Reason: Installation of an additional fair lead in the rudder cables. The rudder cable may catch at the bearing screw of the brake lever.

LTA Nr 1/68

Drawing
 L-267.10-S2/S3

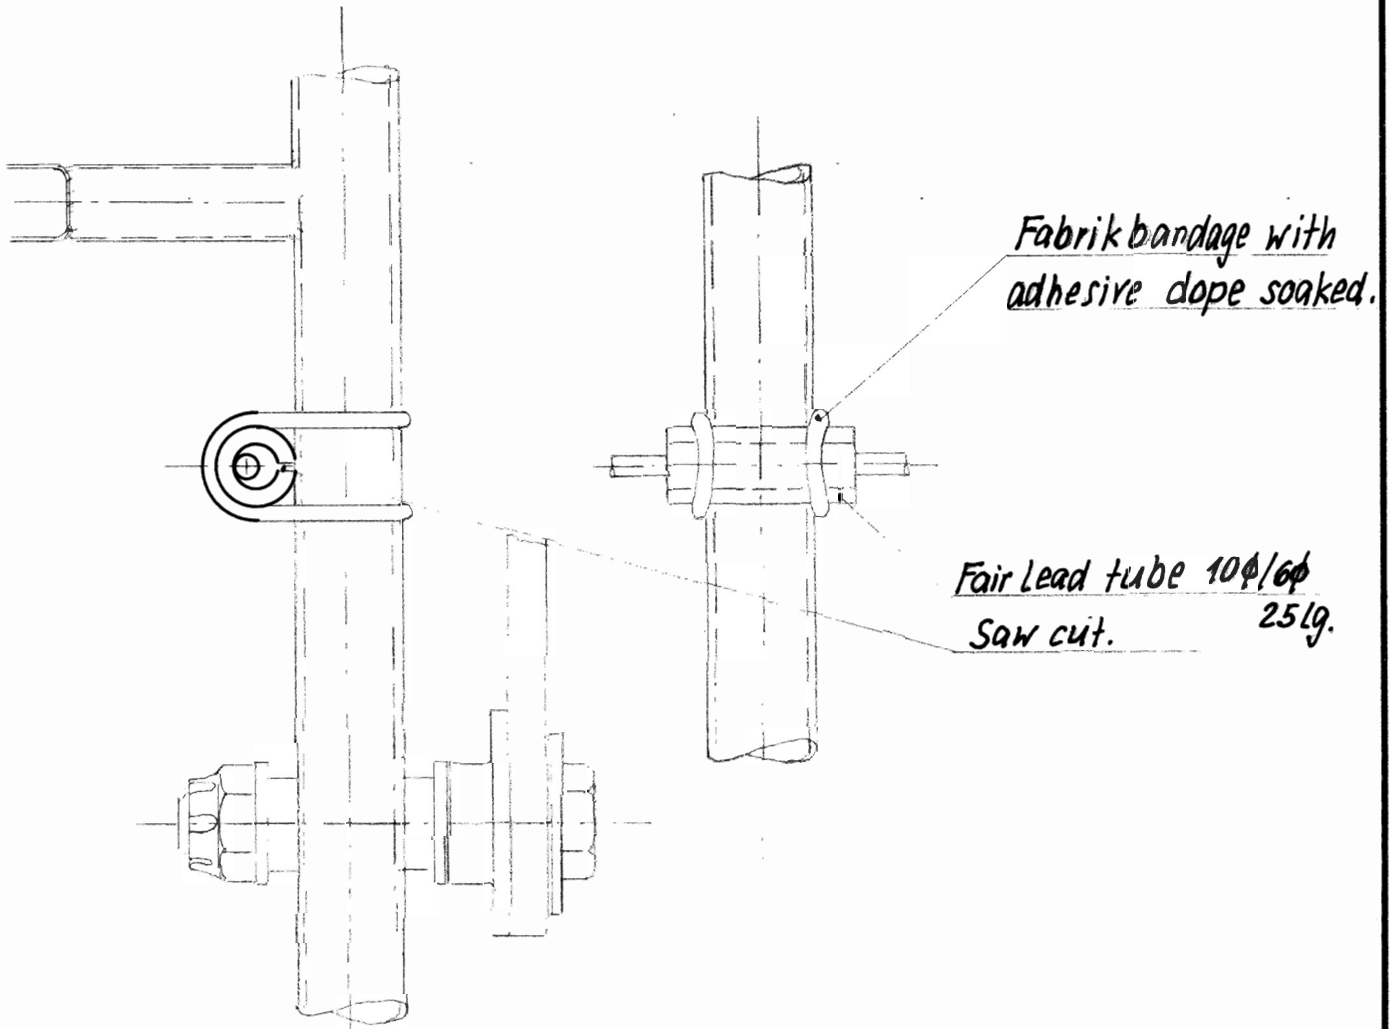
Description of modification:

All remaining aircraft are to be modified according to the drawing below:

All new aircraft beginning with S.No.13047 are modified according to corrected drawings.

Modification to be made
 until 1.5.68.
